# MEETING AGENDA

## Planning & Zoning Commission

Thursday, June 8, 2023 | 7:00 PM

**Case 1: PZ-23-3 – STAR COLUMBUS TRANSPORTATION LLC. – 3810 LACON ROAD** 3 - 32

HILLIARD / FRANKLIN COUNTY, OHIO  
 SITE PLAN  
 FOR  
**STAR COLUMBUS  
 TRANSPORTATION**

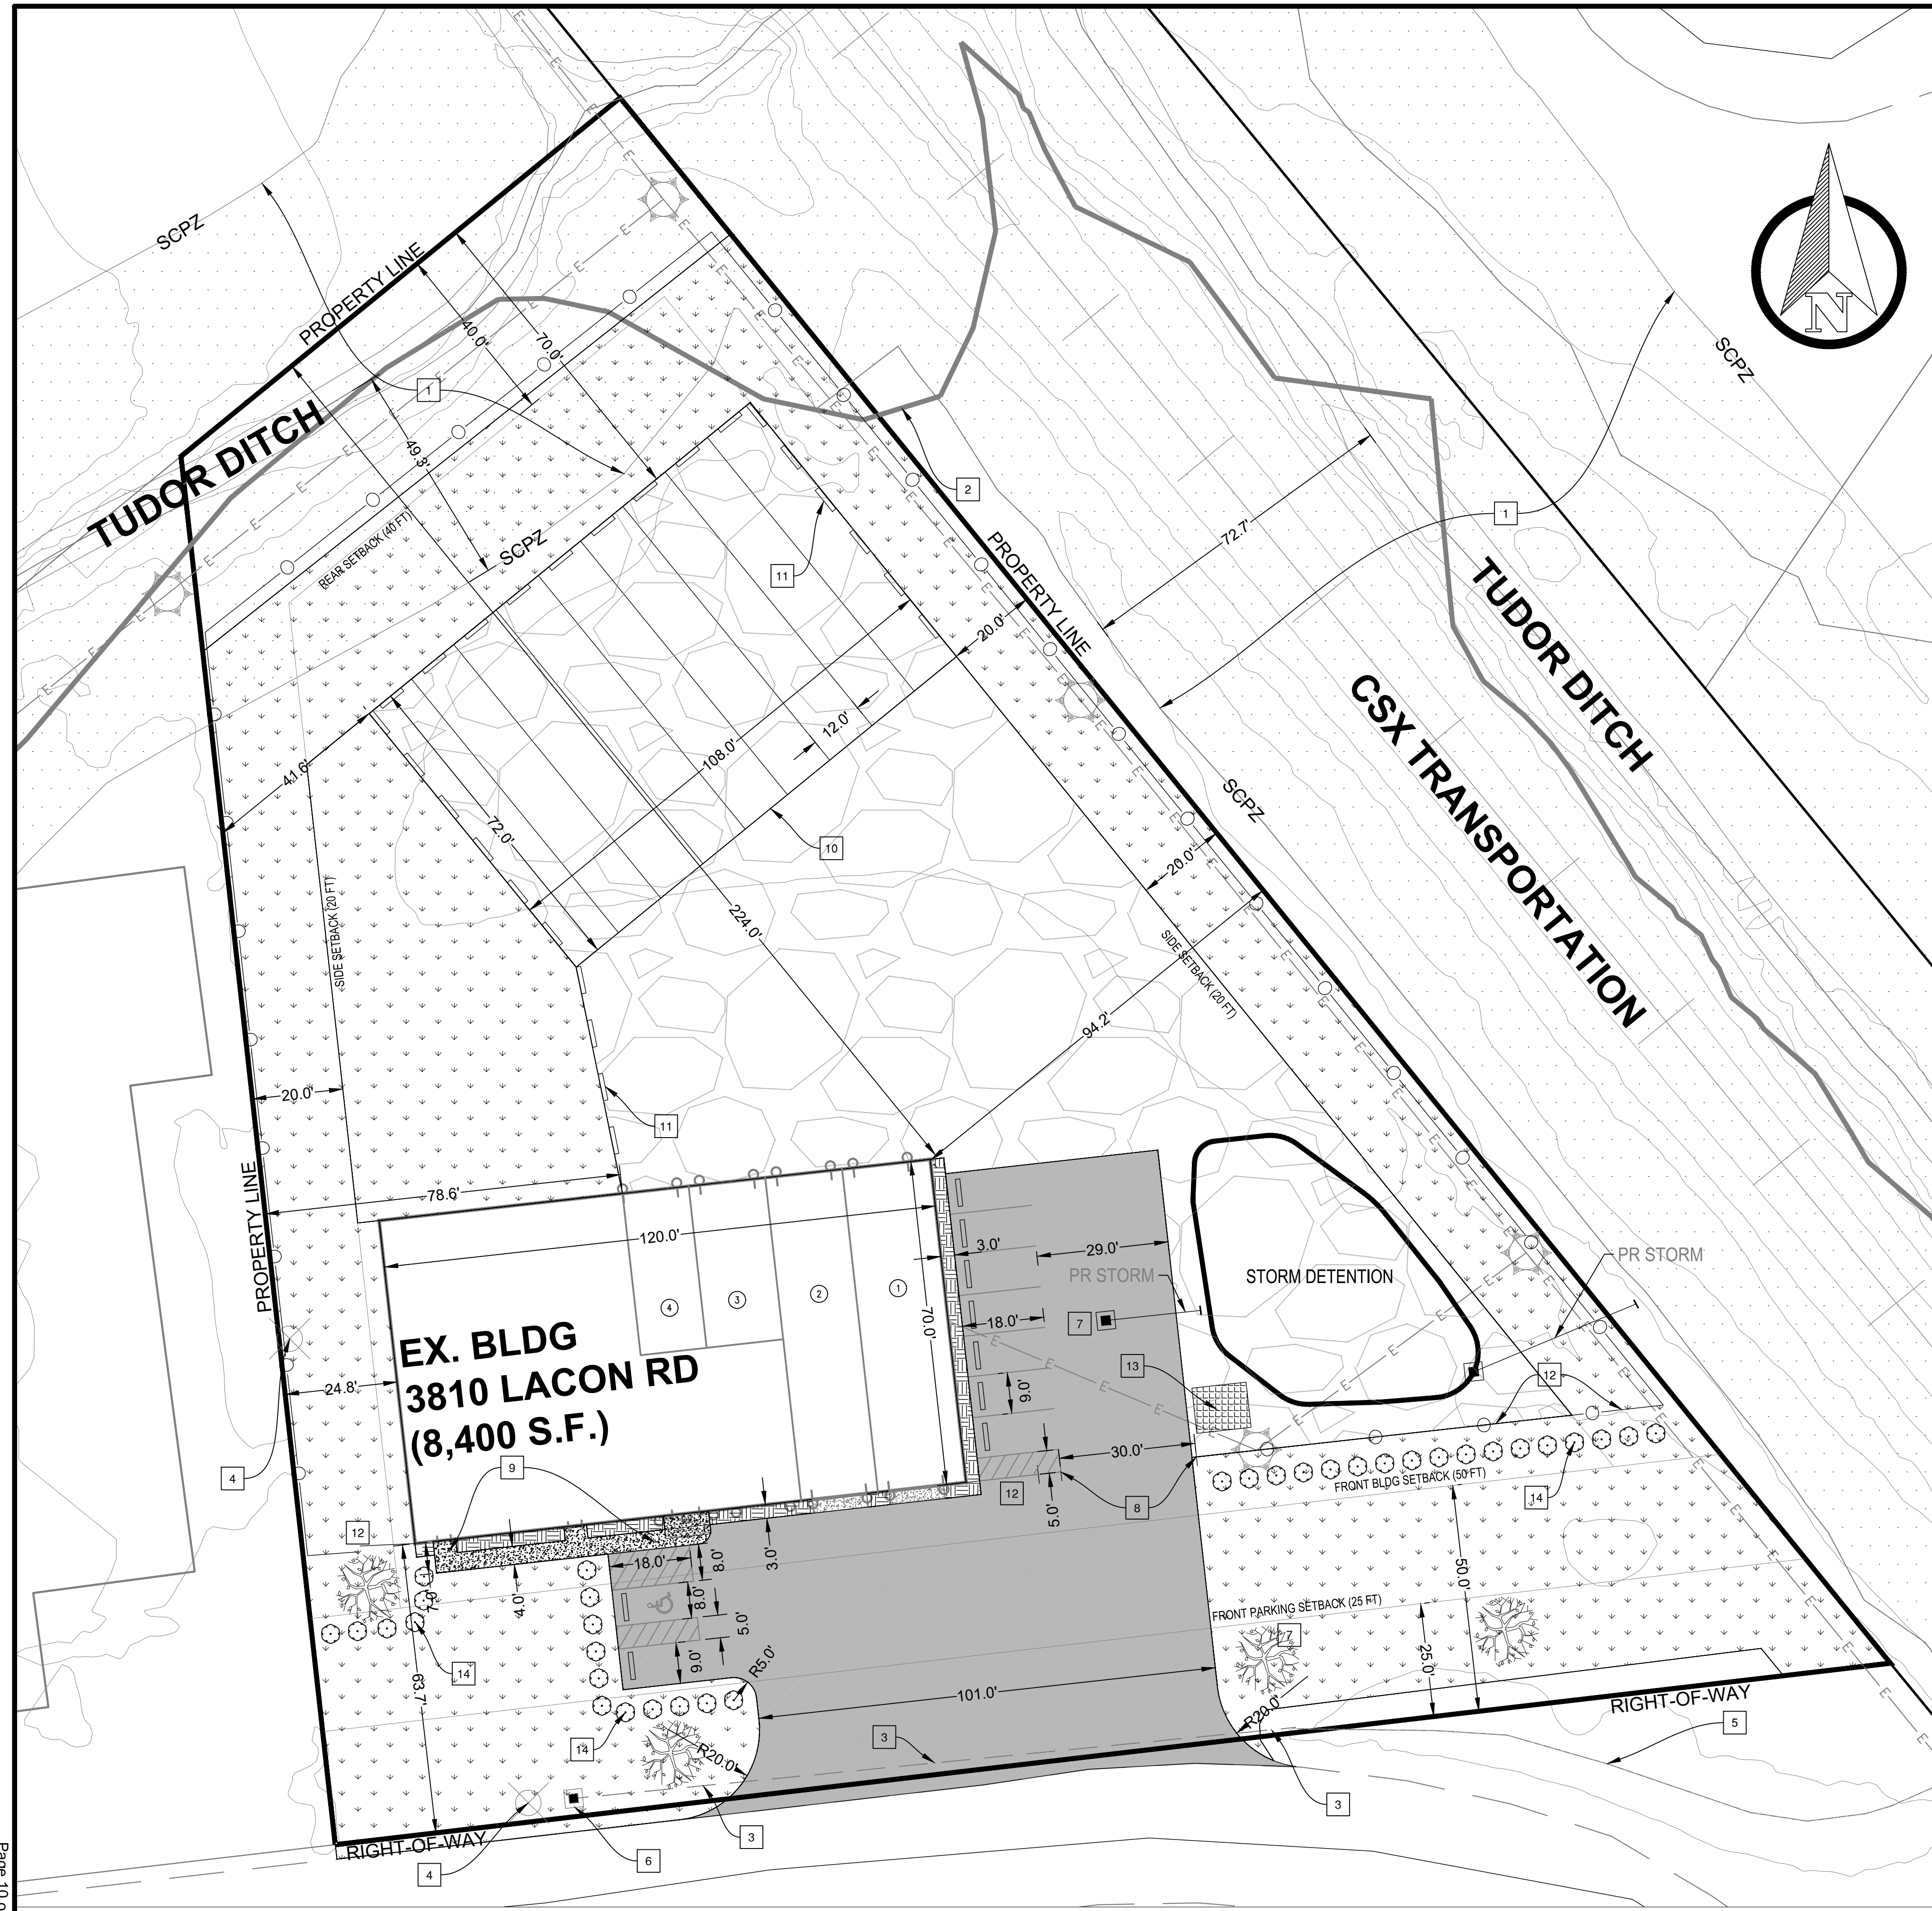
- **Stormwater Management.** The site includes 100-year floodplain and a Stream Corridor Protection Zone. Existing gravel will be removed in these areas and the site will be fine graded and seeded. Plans should note that those areas will be seeded with an approved mix of grasses and/or wildflowers that will be left to grow naturally as part of the stream corridor. Stormwater detention is provided to address runoff and final details will be addressed with the City Engineer as part of permit review. Staff recommends that the area be fine graded and seeded and not indicated as gravel.

- **Parking.** Proposed plans include the paving of a parking lot area on the south and east sides of the building to create a total of 13 spaces, including the service bays. 19 spaces are required and the proposed plan will require a variance from the Board of Zoning Appeals. The Zoning Code prohibits the leasing of spaces for truck parking at this location.

- **Outdoor Storage.** As part of the gravel lot located behind the building, the applicant is proposing to use wheel stops as a barrier along the edge to prevent its expansion. Submitted plans identify a 108'x72' area as outdoor storage (9.6% of the site). Staff identifies the entire 24,000-square-foot gravel area - including identified truck parking and associated maneuvering space - as outdoor storage (30% of the site) that requires a conditional use. Staff recommends that plans be revised to correctly identify the outdoor storage area and that a less mobile solution to contain the outdoor storage area be provided...such as a bollard and chain system that would prevent expansion of the gravel area and simplify enforcement. Plans should also specify that the outdoor storage area (gravel) will be used for Truck and Heavy Equipment Repair parking and that no outdoor storage of parts is permitted.

- **Landscaping.** The applicant has proposed the incorporation of trees and shrubs across the front of the building. Section 1125.05(b) requires 30 shrubs and 2 trees per 100 linear feet of pavement around the perimeter of parking areas. Section 1125.04(c) also requires general landscape areas for the building that includes 168 square feet and 5.6 inches of trees. One interior landscape island is also required by code that would include one tree and 4 shrubs. Staff recommends adjusting plans to meet these aspects of Zoning Code.

- **Service Structures.** Plans indicate a dumpster location behind existing fencing adjacent to the proposed storm water detention area. Code requires service structures to be screened on all four sides and staff recommends that it be relocated to the rear of the building and meet Code requirements for screening.

1. That a zoning certificate is obtained following construction and prior to any conditional use operation on the property;
2. That all plan notes are revised to identify the proposed use as "Truck and Heavy Equipment Repair" and to correctly identify the extent and purpose of the "Outdoor Storage Area;"
3. That the proposed use conforms to the provisions of Hilliard Code Section 1123.17(c) for outdoor storage as approved;
4. That leasing of truck parking spaces is not permitted on the site and that the outdoor storage of truck parts on the site is prohibited unless otherwise specifically approved by City Council; and
5. That any expansion of the approved conditional uses require prior approval by City Council.

4. That revised landscape plans are submitted that meet Code requirements and include one interior parking lot island with required landscaping, subject to staff approval;

APPROVED DRYING/GO SIGN WITH **UNAPPROVED ADVERTISING**

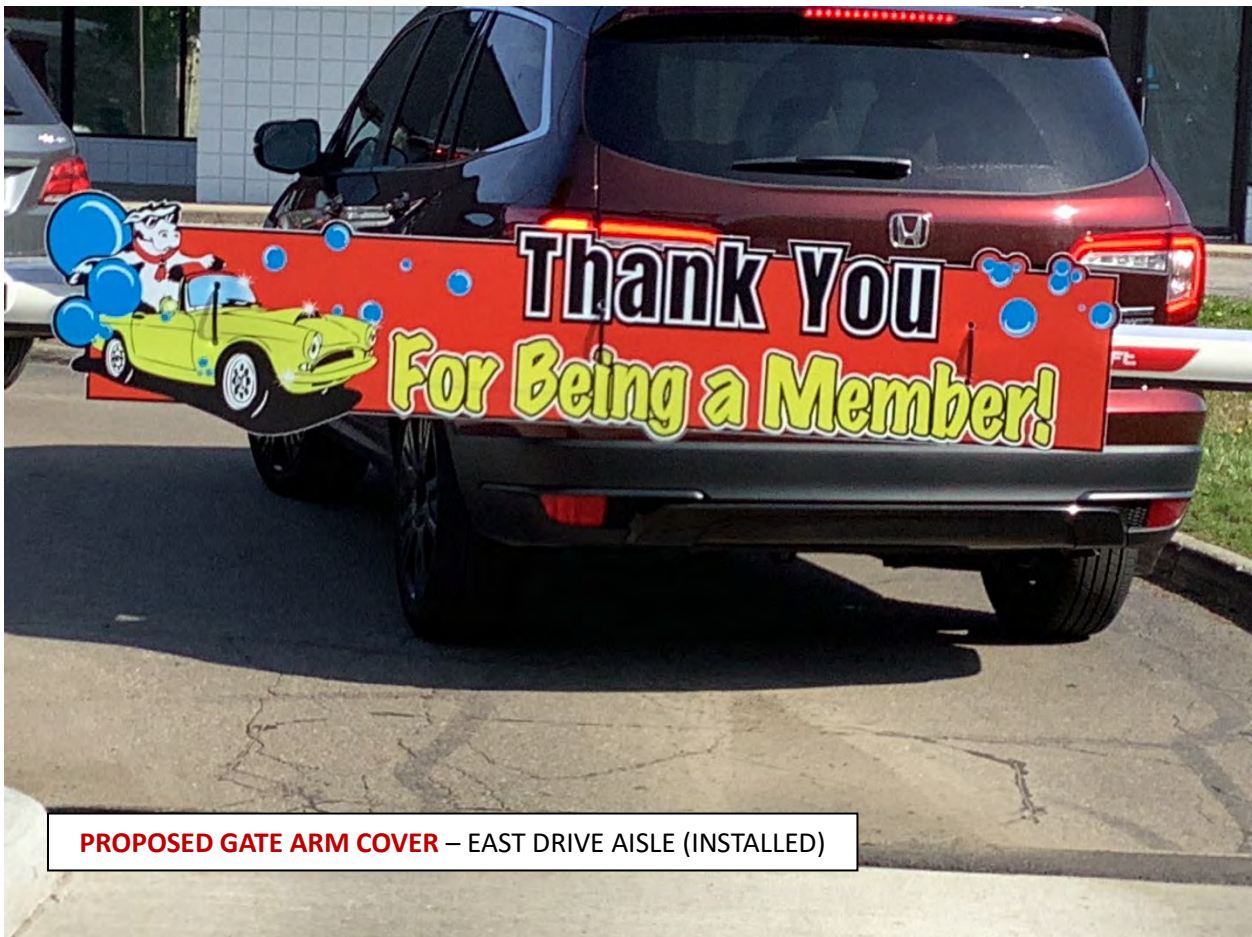
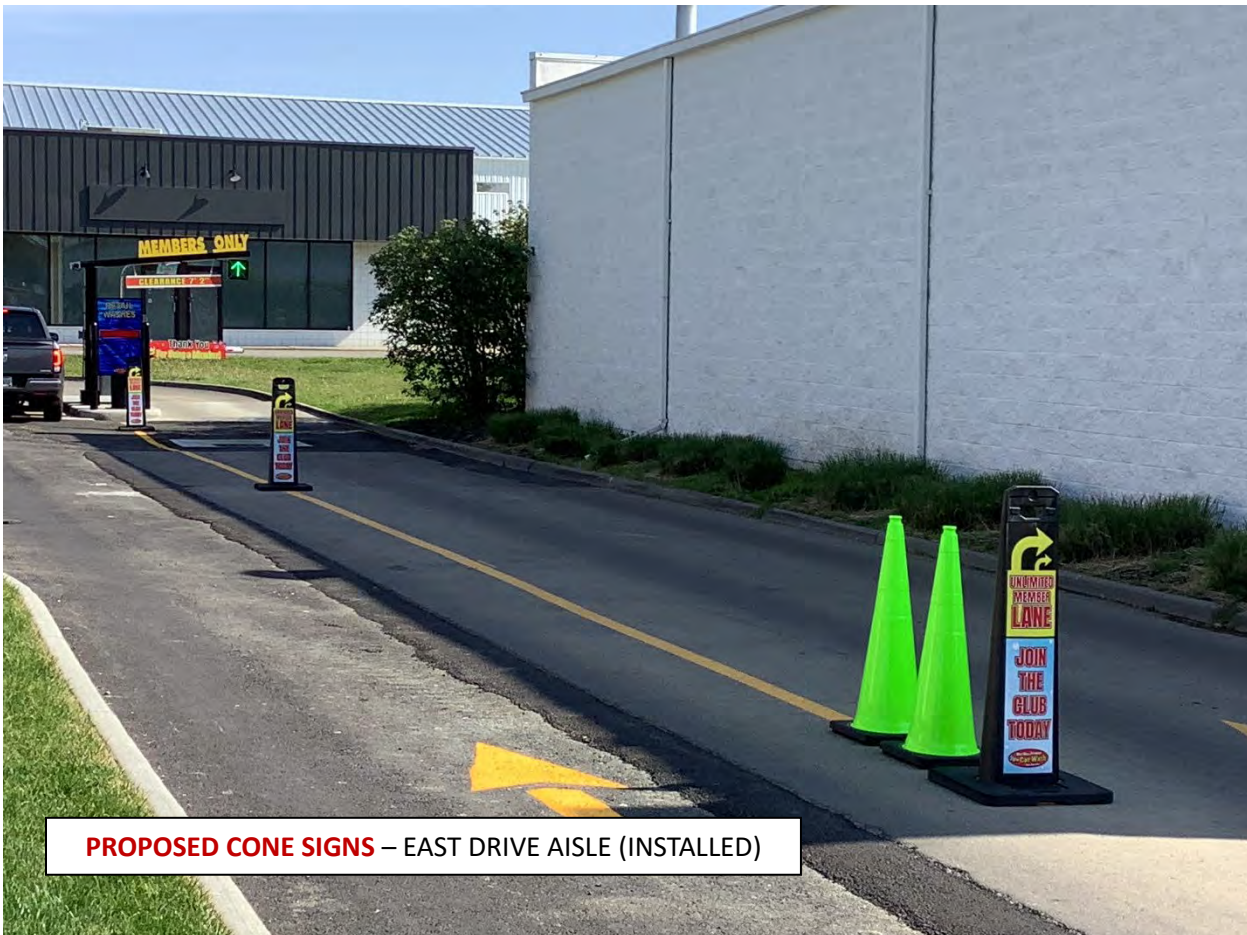
- **Gate Signs (A).** Two interchangeable signs are proposed that would cover the gate arms and provide advertising messages. The proposed signs are 74" x 16" (8.2 square feet each) and include more than four colors as required by Section 1129.02(b)(2) of the Code. These signs have been installed without permits and staff recommends immediate removal.

- **Drying/Go Sign (E).** In January the Commission approved signage with the condition that no bottom advertising panel is permitted (PZ-22-71 Record of Action, January 12, 2023). The approved condition states the following: "That Sign "E" be revised to remove advertising and be no larger than 12 square feet in size and no greater than 7 feet in height." The panel restricted by the Commission has been used for advertising since installation, and the applicant is again requesting approval.

- **Slim LED Lights.** Following approval of the comprehensive sign package in January, unapproved flashing lights that include a red "x" or green arrow were added to the canopy signs at the pay kiosk. This is a request to convert the lights from flashing to solid - similar to a bank drive-thru. Staff recommends approval of the solid lighting if a sign permit is properly obtained.

1. That the proposed Gate Arm Signs, Kiosk Signs, Cone Signs and advertising panel on the Drying Sign be removed immediately;
2. That a sign permit is obtained for the "Free Air" sign;
3. That a sign permit is obtained for the solid illuminated lane signs (green arrow and red "x") located above the pay kiosks; and
4. That no additional signage is permitted on the site without prior approval from the Planning and Zoning Commission.

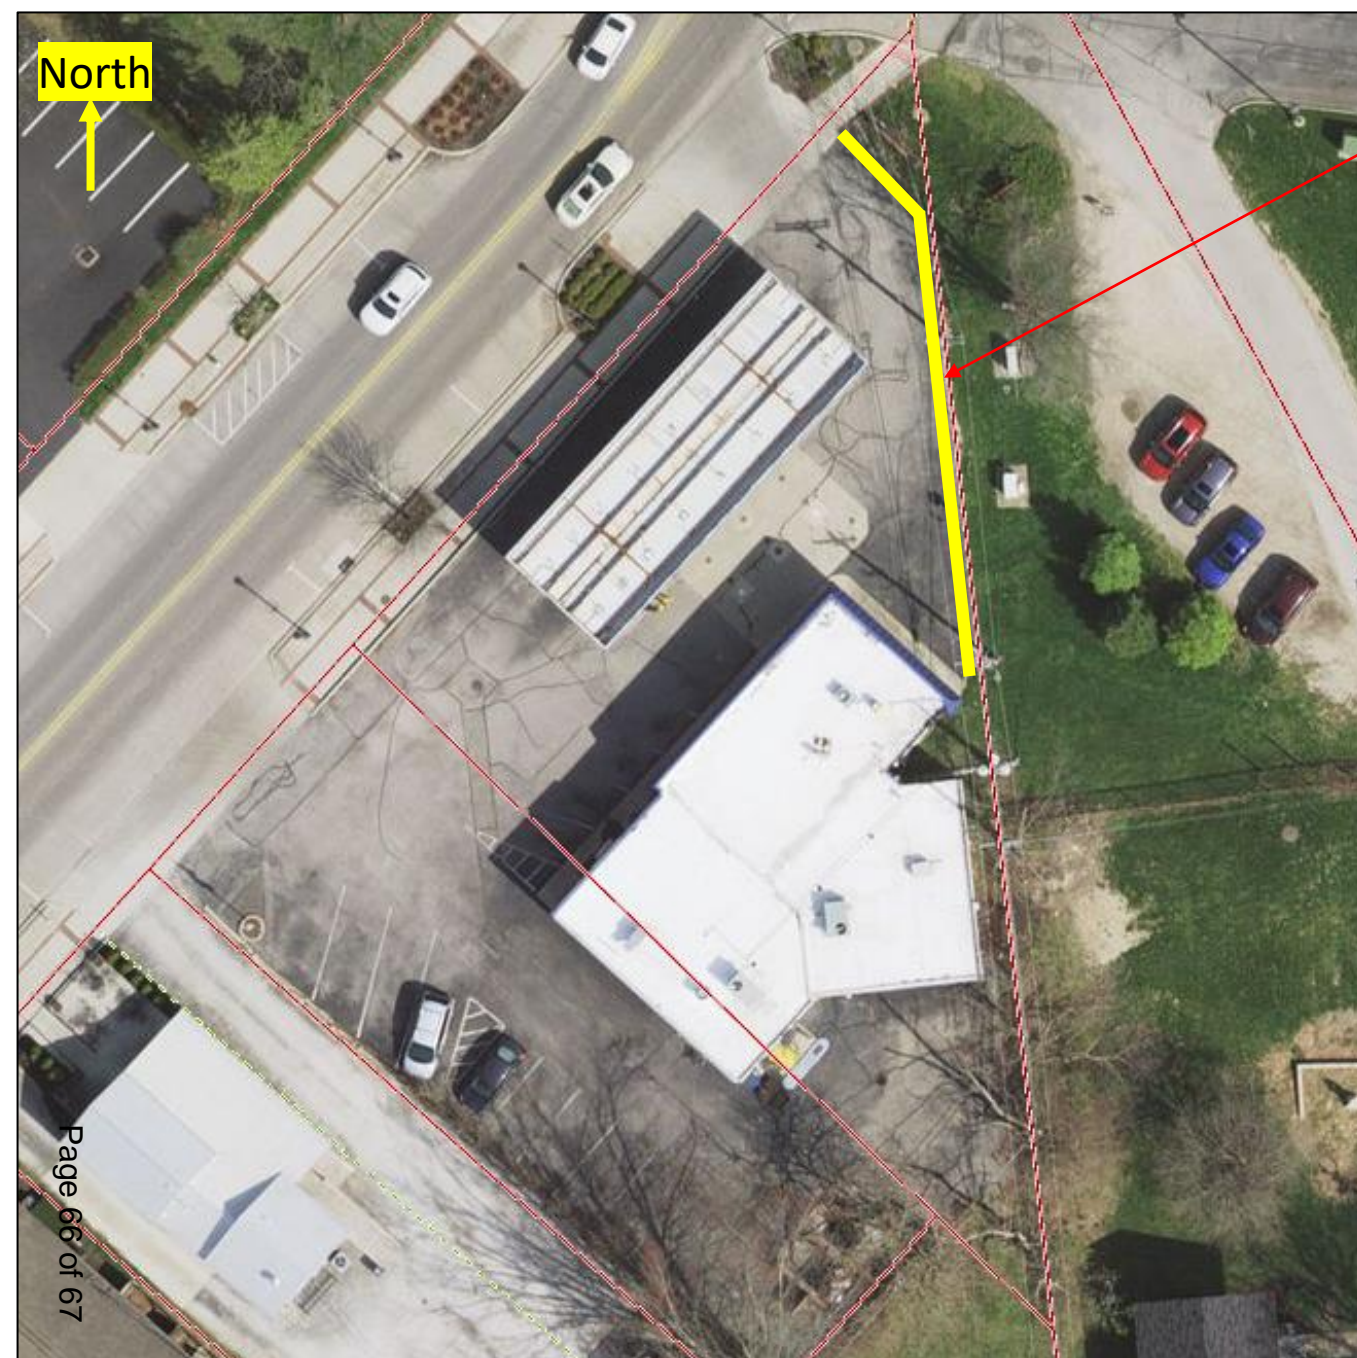
Staff finds that while the proposed construction method is not optimal, the wheel stops will improve the existing pavement edge and reduce property damage. The proposed wheel stops provide a short-term solution to noted issues and can be considered further should the alternative not work. Staff finds that the proposed option meets the intent of the Code and in this circumstance recommends approval with the following two conditions:

1. That the installation of wheel stops according to the proposed plan be provided to the satisfaction of the City Engineer.
2. That the proposed wheel stops are to be concrete finish (gray with no color).
